工務小組委員會在二零零九年一月七日舉行的會議
政府當局需採取跟進行動的事項
項目 PWSC(2008-09)56
49RG 元朗第 3 區公共圖書館及體育館

title 49 RG PUBLIC LIBRARY & INDOOR RECREATION CENTRE IN AREA 3, YUEN LONG 元朗第3區公共圖書館及體育館	drawn by LUK KAI SUN	date JAN 09	drawing no. sk08-07	size A4	scale N/A
	checked by KAH WONG	date JAN 09			
	office ARCHITECTURAL BRANCH	 ARCHITECTURAL SERVICES DEPARTMENT

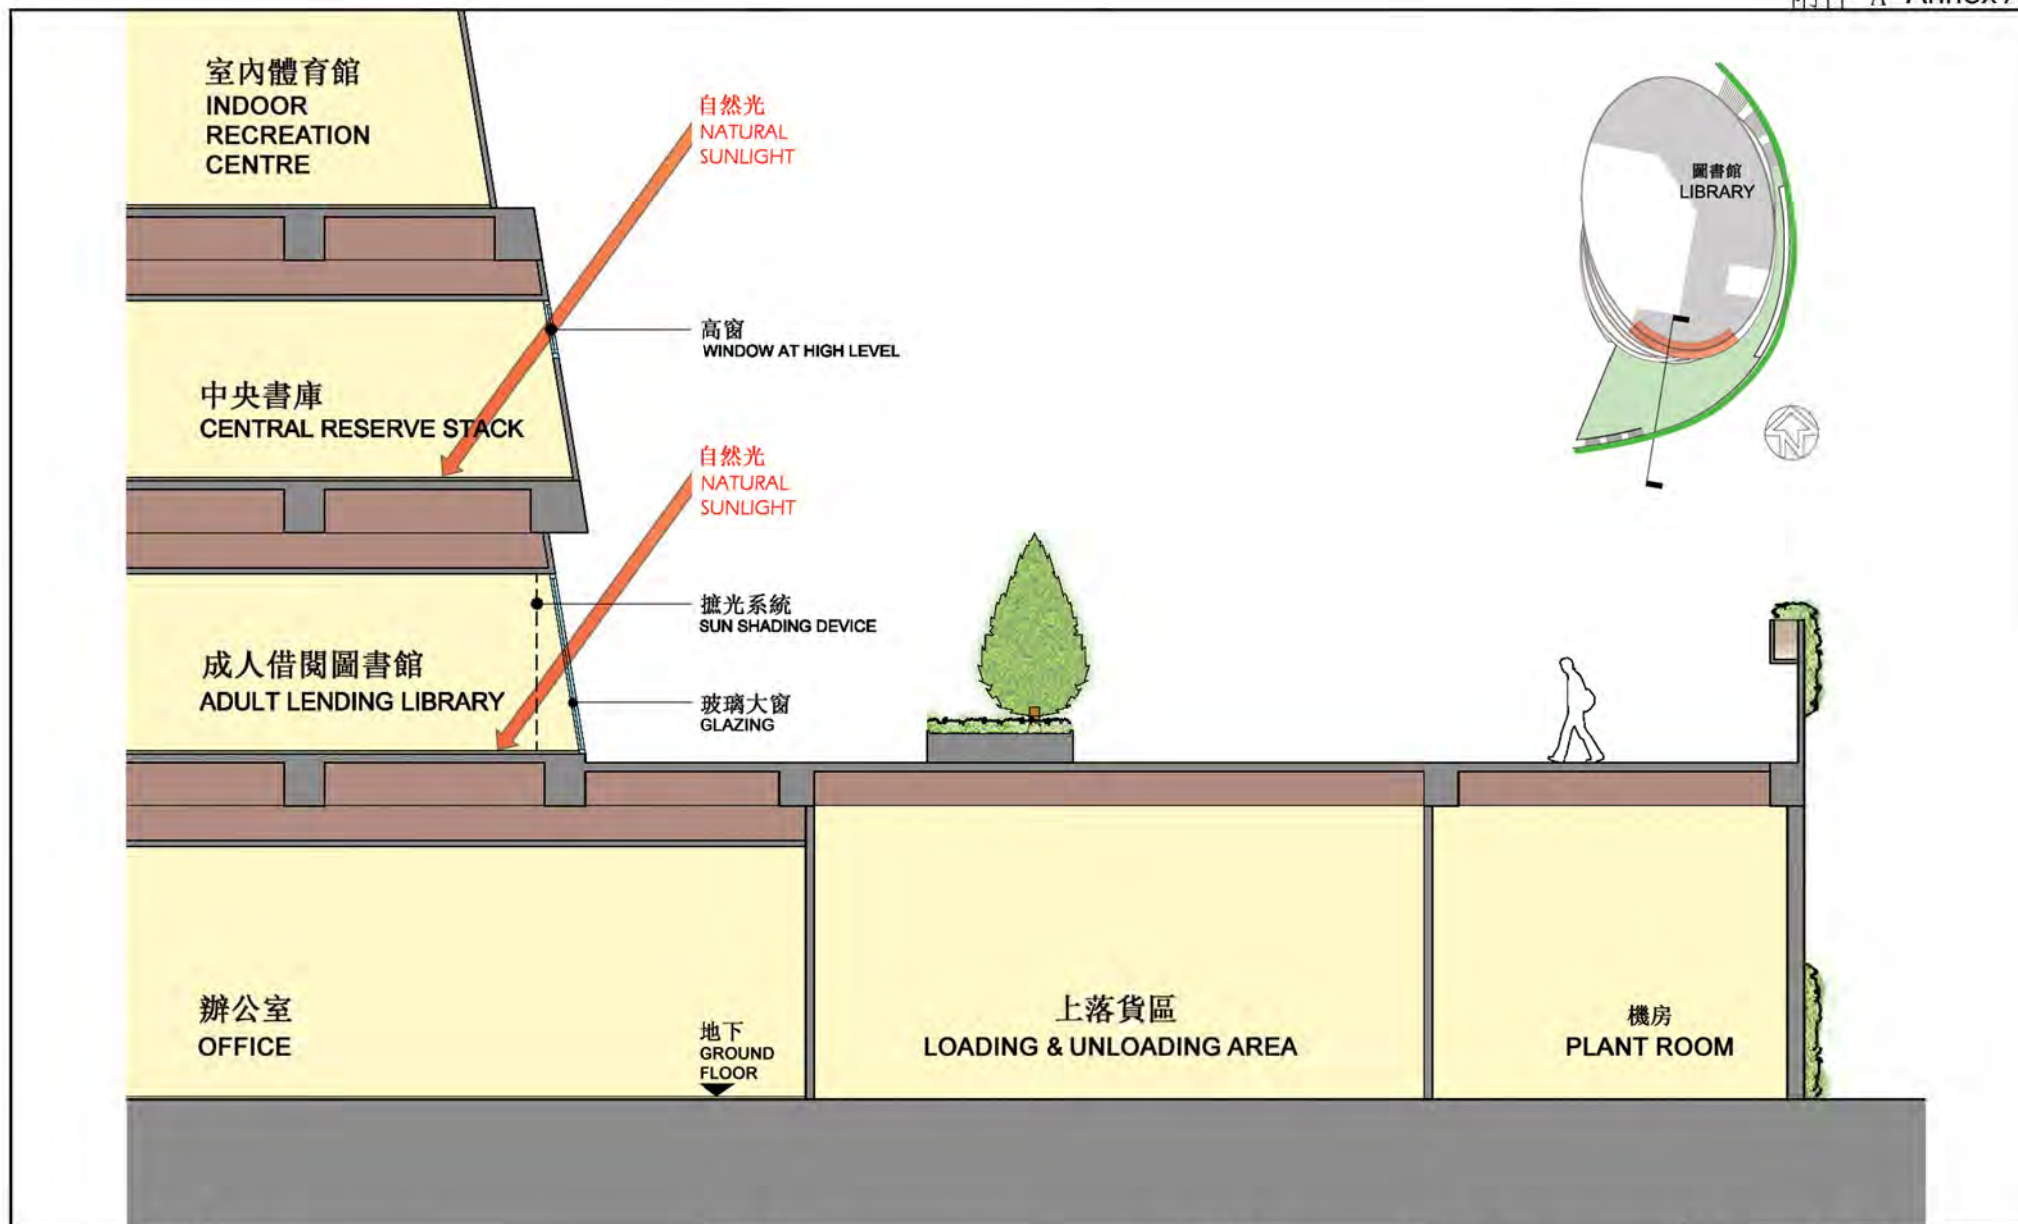
事項 有關劉秀成議員對圖書館是否設有足夠窗戶的關注，並詢問把擬議體育館設於圖書館之上的理由；以及陳偉業議員和甘乃威議員提出為建築物加強綠化措施(包括以垂直種植模式進行綠化)的要求，政府當局會在有關的財務委員會會議舉行前提供進一步資料，當中包括更詳細的平面圖，以供委員參閱。

回應 圖書館的設計已包括設置足夠的窗戶，以便利用天然陽光改善閱讀環境。顯示圖書館窗戶位置的詳細平面圖載於 附件 A 和附件 B。
